## SERVICE LETTER

SL-031725-A

### Introduction of sodium filled exhaust valves and new cylinder heads for ROTAX® Aircraft Engine types 912 and 912 i (Series)

Fig. 1

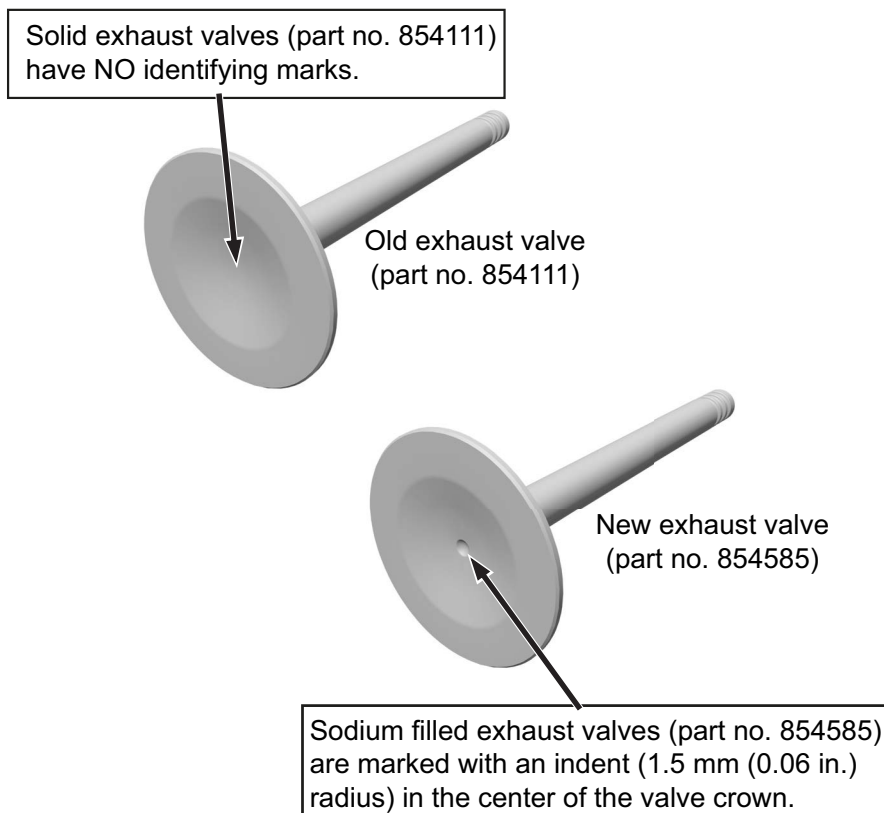
Pos.	Description	Part no.
1	CYLINDERHEAD 2/3 ASSY.	413186
2	CYLINDERHEAD 1/4 ASSY.	413196
1	CYLINDERHEAD 2/3 ASSY.	623774
2	CYLINDERHEAD 1/4 ASSY.	623784
1	CYLINDER HEAD 2/3 ASSY.	413237
2	CYLINDER HEAD 1/4 ASSY.	413238
3	EXHAUST VALVE 32MM	854585

Fig. 3

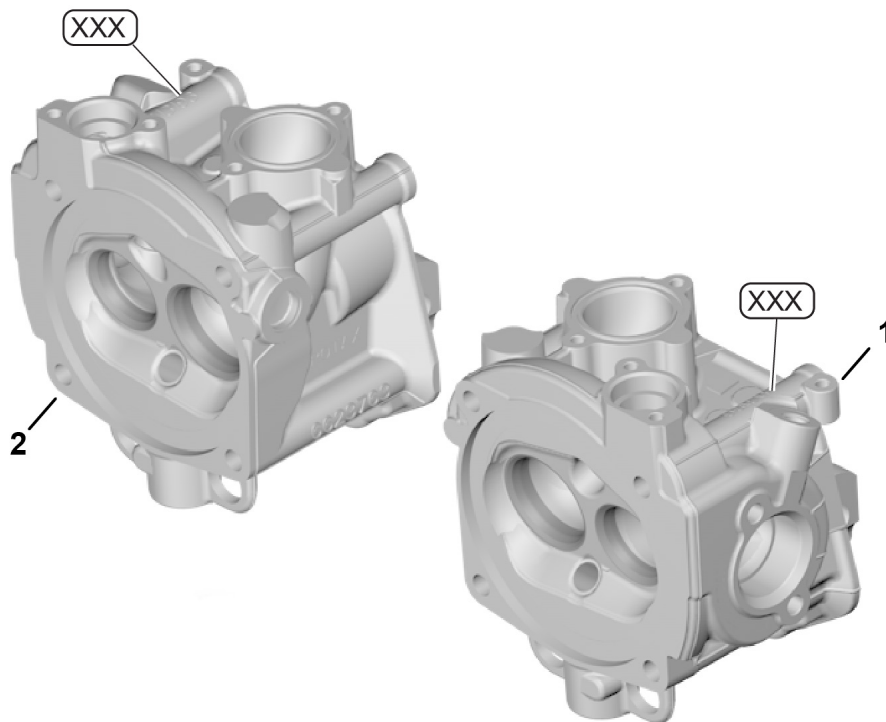
NOTE: XXX - Location of part number.

Pos.	Description	Part no.	Application
1	CYLINDER HEAD 2/3 ASSY.	413186	912 S / ULS
2	CYLINDER HEAD 1/4 ASSY.	413196	912 S / ULS
1	CYLINDER HEAD 2/3 ASSY.	623774	912 i (Series)
2	CYLINDER HEAD 1/4 ASSY.	623784	912 i (Series)
1	CYLINDER HEAD 2/3 ASSY.	413237	912 A / F / UL
2	CYLINDER HEAD 1/4 ASSY.	413238	912 A / F / UL
